CITY OF ARLINGTON PRAIRIE CREEK DRAINAGE IMPROVEMENTS PHASE 2A CONSTRUCTION - PROJECT NO. P02.371

AS BUILT

SHEET
L-1
11 of 15

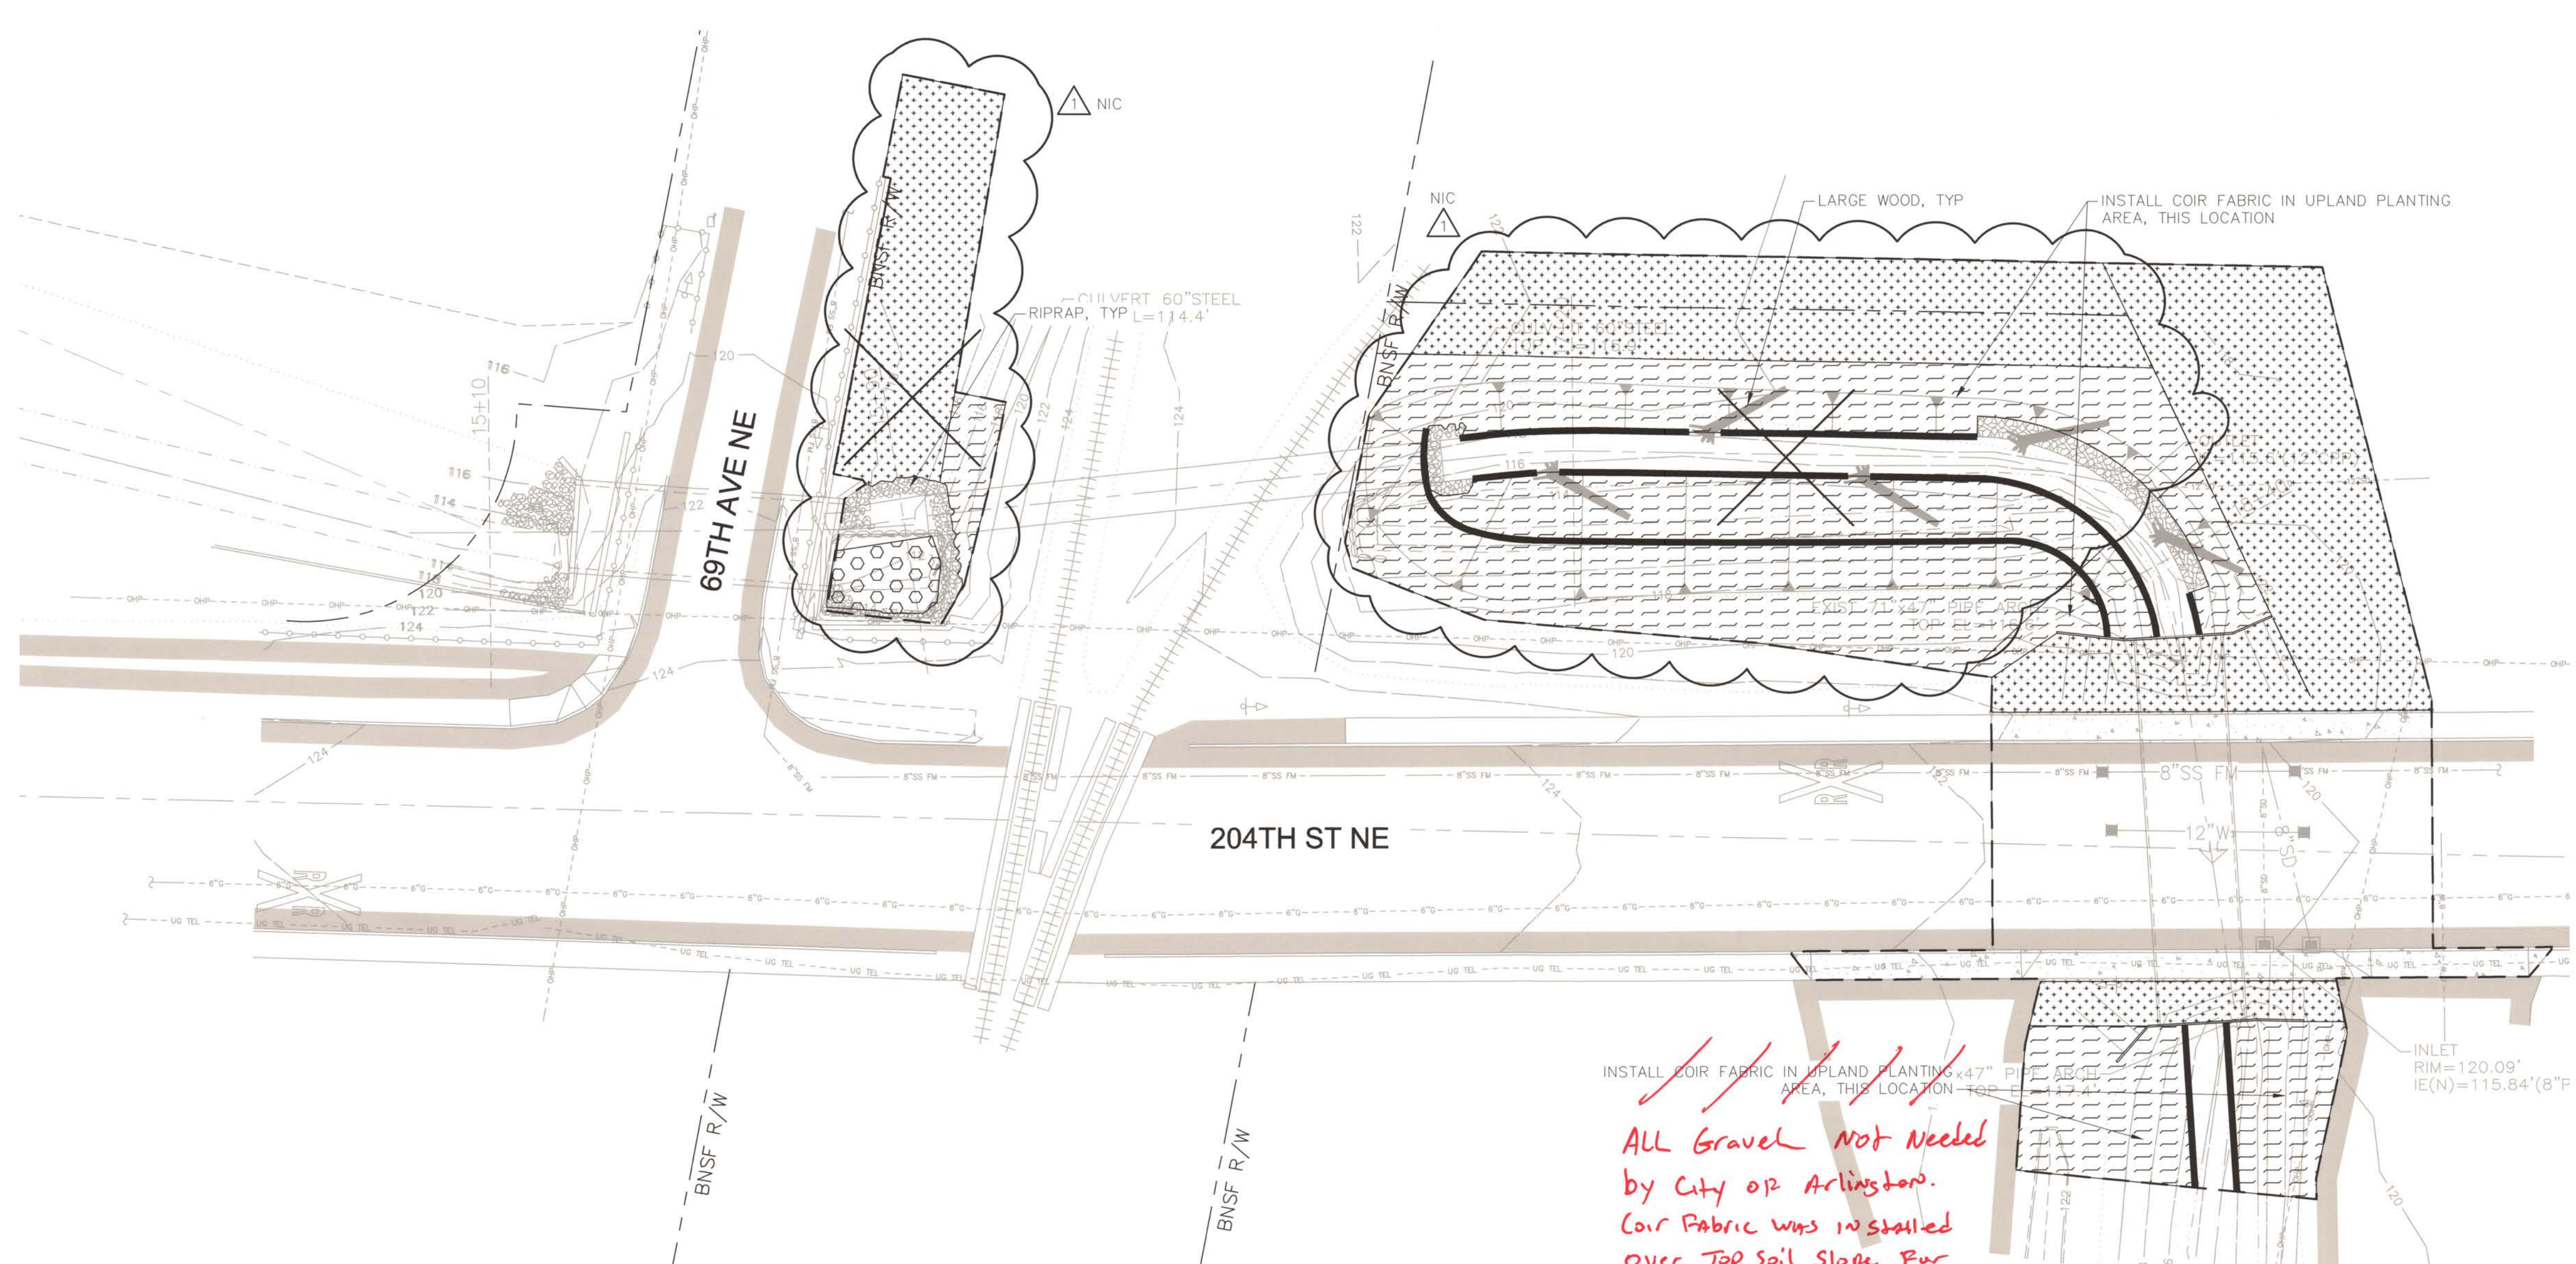
INSTALL COIR FABRIC IN UPLAND PLANTING AREA, THIS LOCATION TO PROTECT EROSION

ALL Gravel Not Needed by City or Arlington. Coir Fabric was installed over Top Soil Slope For Protection
